## City of Savannah Mobility and Parking Services Request to Relocate Nina Pape Historical Marker

**Petitioner:** City of Savannah Mobility and Parking Services, Sean Brandon  
**File No.:** 25-005947 HM  
**Address:** 906 Drayton Street  
**PIN:** 20044 20012  
**Staff Reviewer:** Jodie Brown, AICP  
**Date:** January 8, 2026

**NATURE OF REQUEST:**

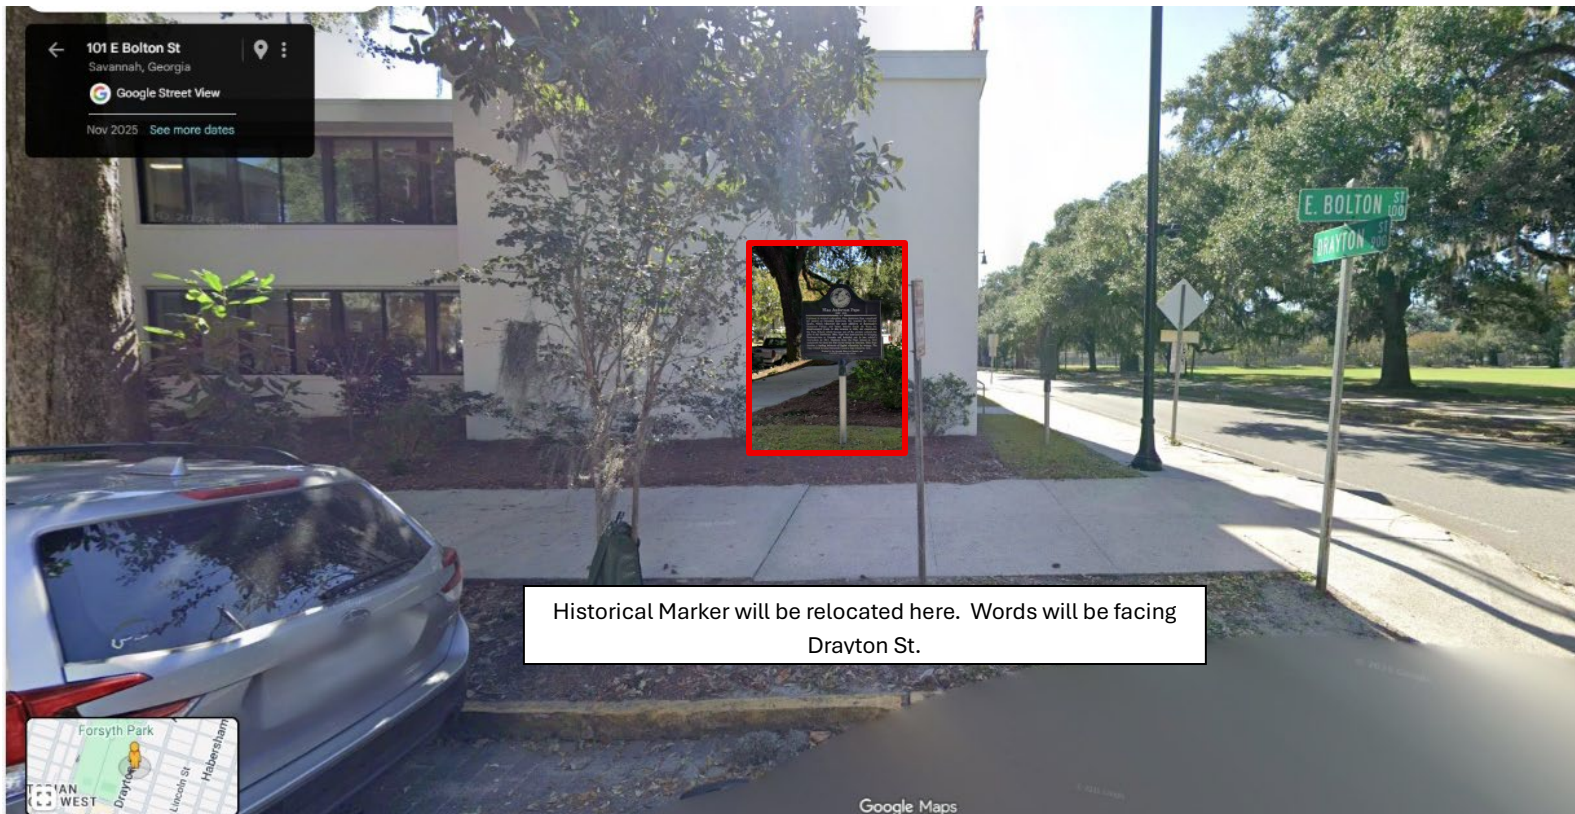
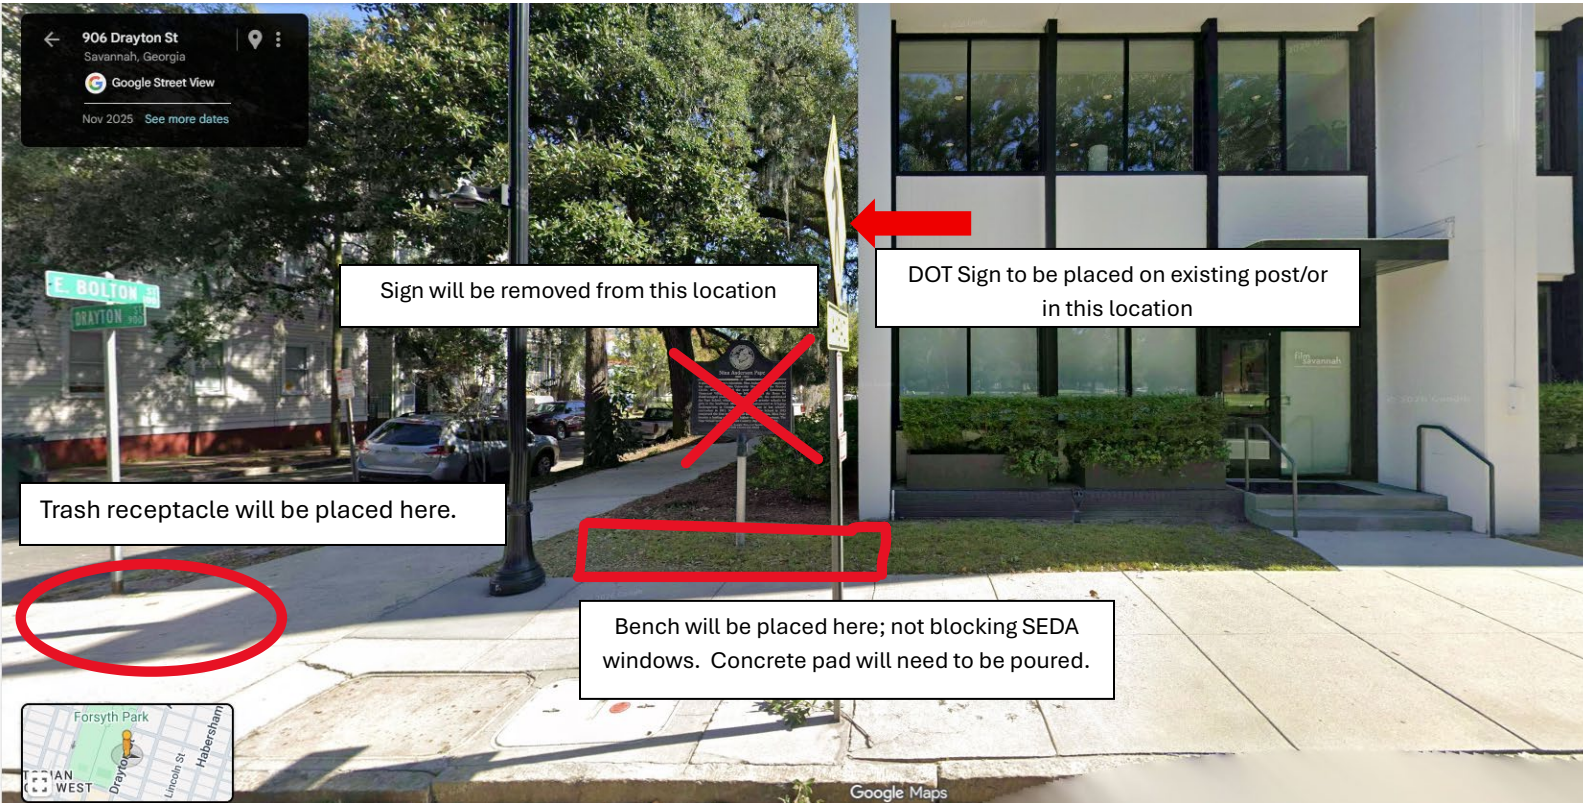
Sign will be in line with where the yellow curb line ends

Post will be in the middle of the lawn area. Parking and Municipal Archives conducted a site visit to confirm the marker would not be obstructed nor would it obstruct the sidewalk or windows and is visible from Drayton.

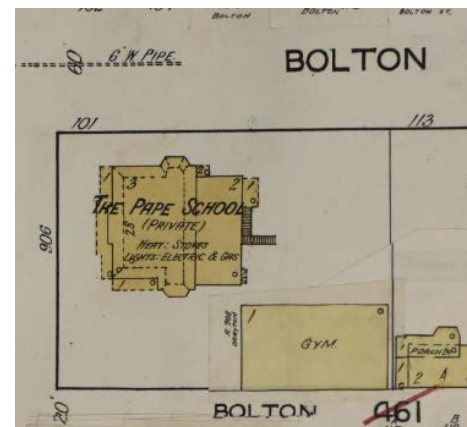
Per the Sanborn Map the Pape School, the school was located on the east side of Drayton Street between Bolton Street and Bolton Lane. Repositioning the marker elsewhere along the street frontage between Bolton Street and Lane would be appropriate as it maintains the marker within the school's original parcel.

The proposed location is within the small front setback. The current location is at the northwest corner of the parcel. The proposed location could be either at the middle of the parcel fronting on to Drayton or at the southwest corner of Drayton Street and Bolton Lane. While the middle of the parcel seems to be clear of any other type of signage, the southwest corner is busier. Signage for the building, a stop sign, palm tree and light post are all within or close to this location. The addition of a sign would just make this corner more crowded.

At the middle of the parcel, there is only grass and planters up against the building. At the southwest corner there is grass and a palm tree. Palm trees generally have a root ball close to the base of the tree. It does not have roots that spread out. If the marker is set slightly away from the base of the tree, there should be no impact at either location.

**Staff recommends that the Savannah Historic Site and Monument Commission recommend APPROVAL to the Savannah City Council for the relocation of the Nina Anderson Pape Historical Marker at 906 Drayton Street AS REQUESTED because the work meets the standards within the Master Plan and Guidelines for Markers, Monuments, and Public Art.**

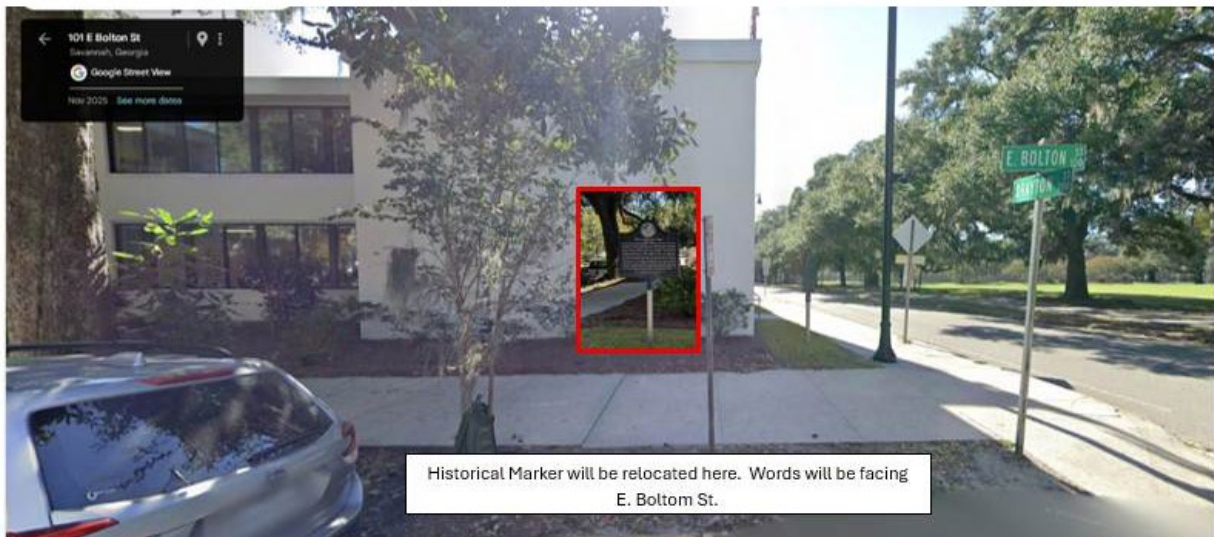
GHS approves of the proposed location on E. Bolton Street, on the condition that the historical marker plaque faces perpendicular to the road (facing Drayton Street), rather than the proposed parallel-facing position toward E. Bolton Street. Do you have any questions or concerns about that?

We have determined that the below stipulations are achievable. I will keep you updated as we progress through this process.
